Product Change Notification

Change Notification #: 119185-00

Change Title: Intel® Server System R2308WFTZSR, Single, PCN 119185-00, Product Design, Label FW revision and PSU label updates

Date of Publication: July 14, 2022

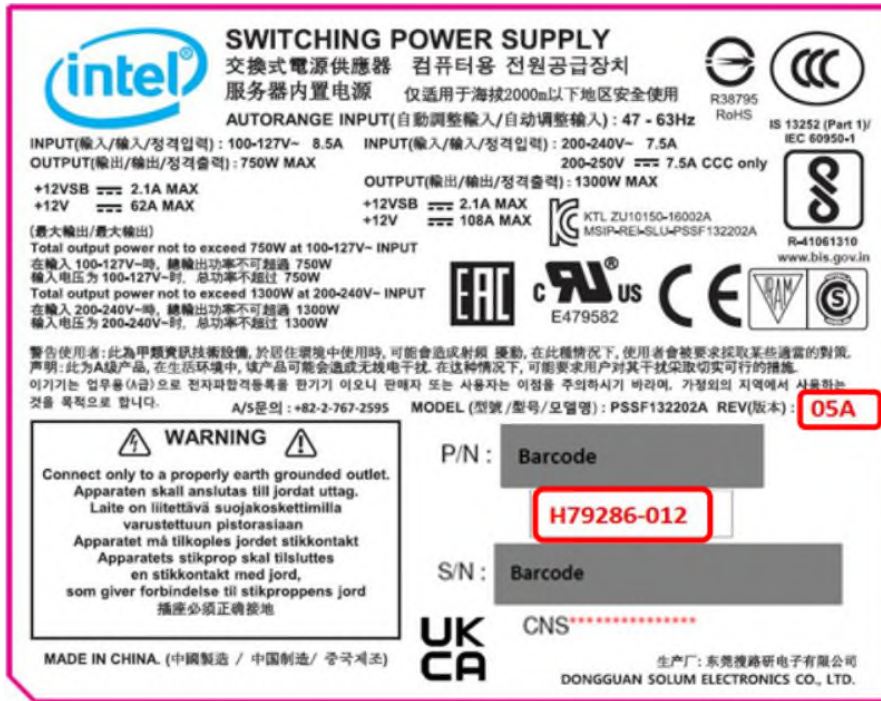
- The 1300W Power supply is changing from H79286-011 to H79286-012 due to a firmware upgrade from 26.5.128 to 29.5.128 and a minor hardware change, there is no impact on functionality.
